STAFF RECOMMENDATION
2819 Hillside Drive
January 16, 2019

Application: New Construction--Infill
District: Hillsboro-West End Neighborhood Conservation Zoning Overlay
Council District: 18
Map and Parcel Number: 10410022000
Applicant: Franz Baudenbacher
Project Lead: Paul Hoffman, paul.hoffman@nashville.gov

Description of Project: This application is a redesign of new construction approved by the Commission in 2014. The Preservation Permit has expired.

Front Elevation

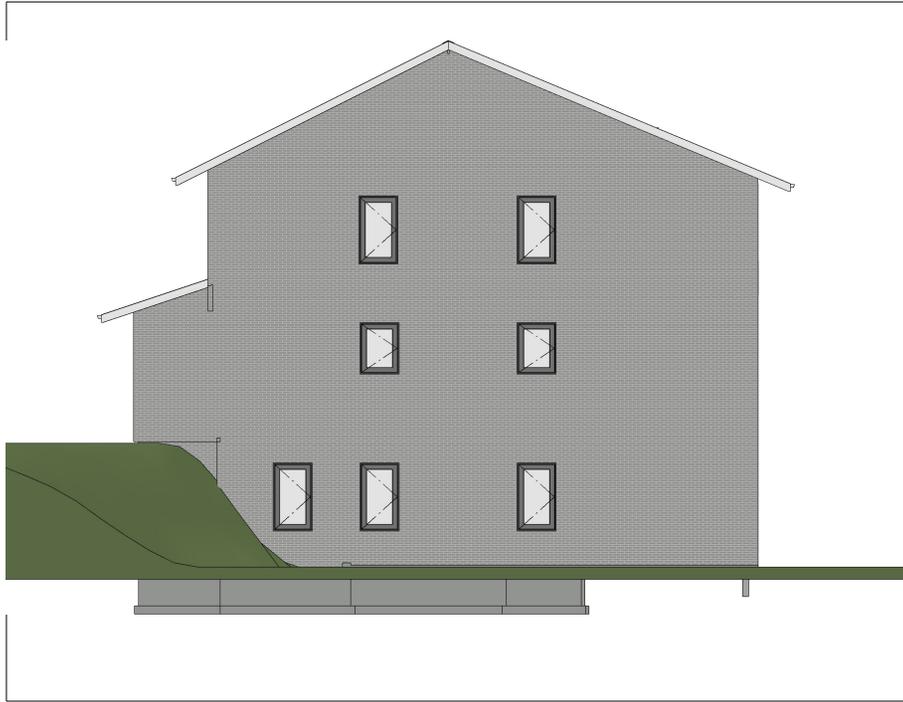
Height & Scale: The ridge height was approved in 2014 at thirty-three feet, nine inches (33' 9") from the finished floor height at its tallest point; the redesign has a ridge height of thirty-one feet (31') from the finished floor height with a simpler roof form. The extreme grade results in a basement level at the rear of the building. The width is fifty-eight feet (58'), which has not changed from the previously approved design. The new structure meets section II.B.1.a. and b.

Roof form: The proposed roof form is a slightly asymmetrical side-gable form, with pitches of 5/12 and 6/12. The side gable is a roof form commonly found in Hillsboro-West End and more in keeping with the district than the previous roof form. The roof form and pitch meets section II.B.1.e.

Proportion and Rhythm of Openings: The majority of the windows are generally twice as tall as they are wide, meeting the historic proportion of openings. They are casement and fixed windows, rather than the more traditional double-hung windows but are appropriate for this more contemporary design. There are two sets of square windows on each side elevation; as a mix of window sizes is sometimes seen on historic buildings, staff finds the fenestration to meet the design guidelines. There are no large expanses of wall space without a window or door opening.

A condition of the previous approval was that all double windows have a 4”-6” mullion between them and Staff recommends the same for the current proposal.

1. The finished floor height shall be consistent with the finished floor heights of the adjacent historic houses, to be verified by MHZC staff in the field;
2. The foundation masonry be a different material or color than the cladding brick, to distinguish the foundation;
3. Double and triple windows have a four-six inch (4”-6”) mullion between them;
4. Staff approve the roof color, masonry, windows, doors, porch columns, railings, prior to purchase and installation;
5. The HVAC shall be located behind the house or on either side, beyond the mid-point of the house.
